File # ZON2005-00230 SUB2005-00018

**PUD &
SUBDIVISION STAFF REPORT**

Date: February 17, 2005

DEVELOPMENT NAME McMurray Place

SITE PLAN

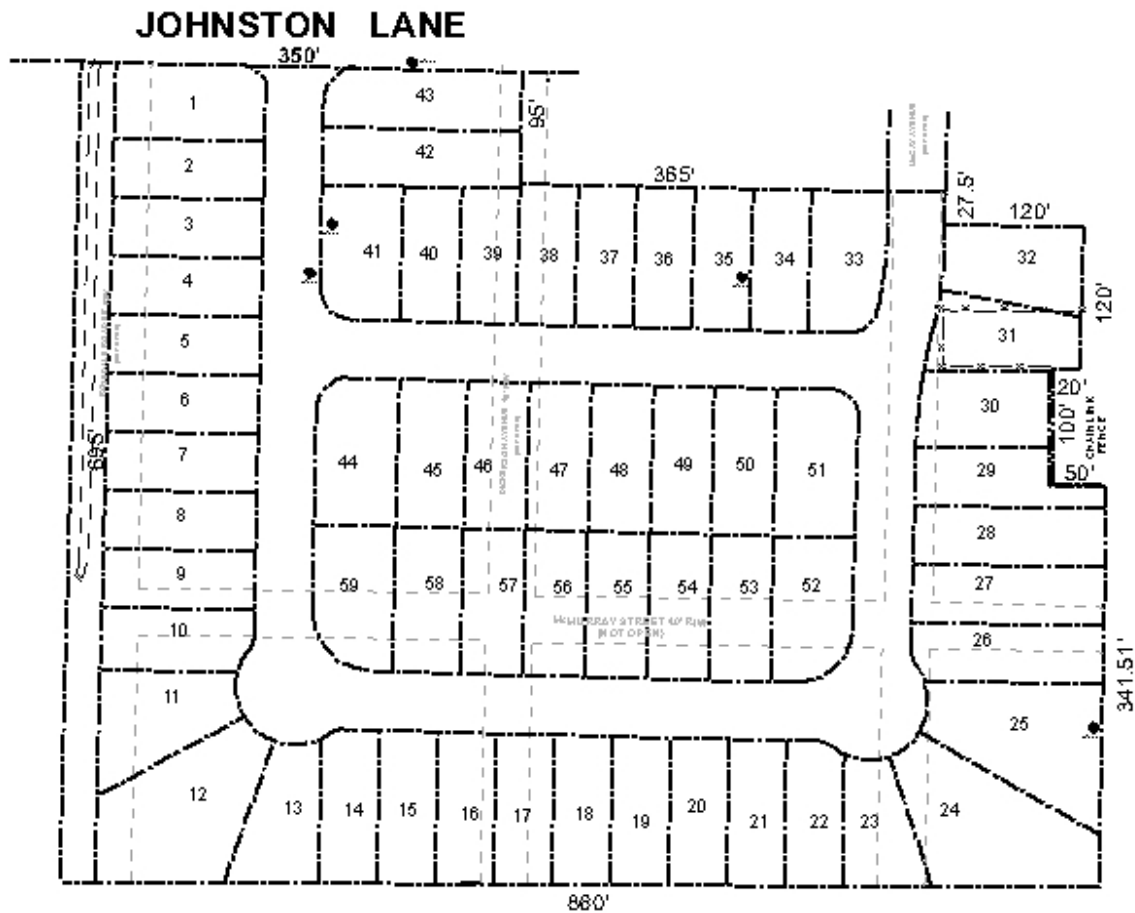
In general, the PUD meets the requirements for PUD approval. However, it should be noted that the modified grid pattern of the proposed development lends itself to connection to the existing rights-of-way of either McCay Avenue to Johnston Lane or McMurray Street to Schaub Avenue. Either of these connections would not only help preserve the existing grid pattern that is prevalent in Pinehurst, but would also afford a second point of access for the development.

The reduction in lot size and width and increased site coverage are typical components of a zero lot line development. Additionally, the plan proposes a 20' setback along side streets for corner lots. While individual lot sizes are reduced, the overall density for a R-1, Single-Family Residential development is being maintained.

No common area shown for stormwater detention which is required for this project. Significant existing stormwater problems downstream from proposed development. MINIMUM requirements will be detention for a 100 year storm with a 10 yr release rate. Must comply with all stormwater and flood control ordinances. Any work performed in the right of way will require a right of way permit

The plat has been revised to reflect the connection to the McCay Avenue street stub, as recommended in the original staff report. This connection must be constructed from the new subdivision street to Johnston Lane.

Planned Unit Development: based on the preceding, it is recommended that this application be approved subject to the following conditions: 1) *construction of the connection to McCay Avenue, from the new subdivision street to Johnston Lane*; 2) completion of the vacation process for existing rights-of-ways within the proposed subdivision; 3) *compliance with City Engineering Comments (No common area shown for stormwater detention which is required for this project. Significant existing stormwater problems downstream from proposed development. MINIMUM requirements will be detention for a 100 year storm with a 10 yr release rate. Must comply with all stormwater and flood control ordinances. Any work performed in the right of way will require a right of way permit)*; and 4) full compliance with all municipal codes and ordinances.

Subdivision: Based on the preceding, it is recommended that this plat be granted Tentative Approval subject to the following conditions: 1) *1) construction of the connection to the existing right-of-way of McCay Avenue, from the new subdivision street to Johnston Lane*; 2) completion of the vacation process for existing rights-of-ways within the proposed subdivision; and 3) *compliance with City Engineering Comments (No common area shown for stormwater detention which is required for this project. Significant existing stormwater problems downstream from proposed development. MINIMUM requirements will be detention for a 100 year storm with a 10 yr release rate. Must comply with all stormwater and flood control ordinances. Any work performed in the right of way will require a right of way permit).*
